# Summary for DRH15-00098

James Marsh-CSHOA request Design Review approval to construct a seven story, 101,400 square foot hotel, restaurant and associated site work on property located in a C-5DD (Central Business with Downtown Design Review) zone.

## Planning Division Staff Report

A2.0  
ORIGINAL SHEET SIZE  
24" x 36"

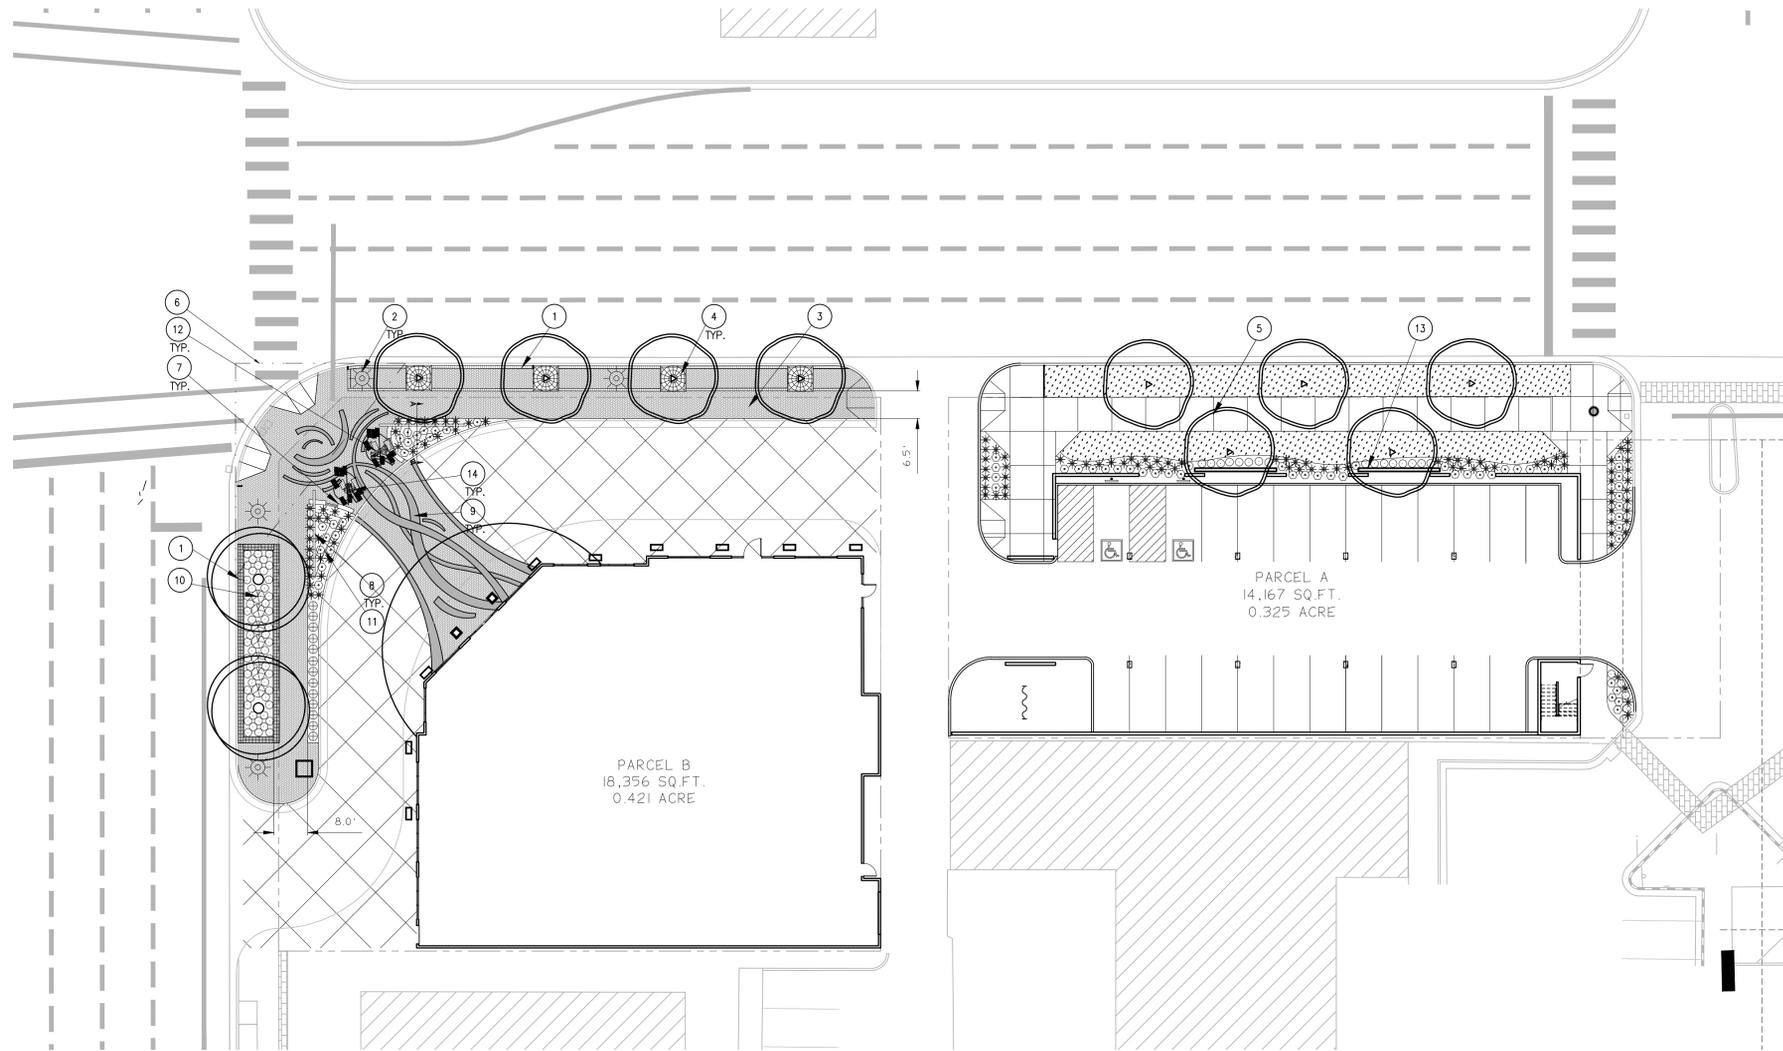
- × No trash enclosures were noted on the proposed site plan. Please review the design requirements and submit a site plan which includes detailed enclosure drawings.

**1 LANDSCAPE PLAN**  
SCALE: 1" = 20'-0"

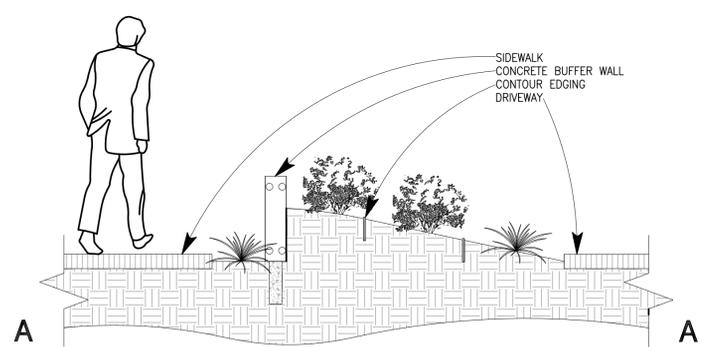
The streetscape on the west side of the alley is shown as trees in tree grates. American Linden trees are used within the tree grates. The applicant should use a modular suspended pavement system or similar system to allow for better root growth and health of the trees. The trees located within the tree lawn and the planters along Capitol Boulevard will not be required to use the same system as the root growth will span in a horizontal manner and provide for an appropriate tree canopy within the system.
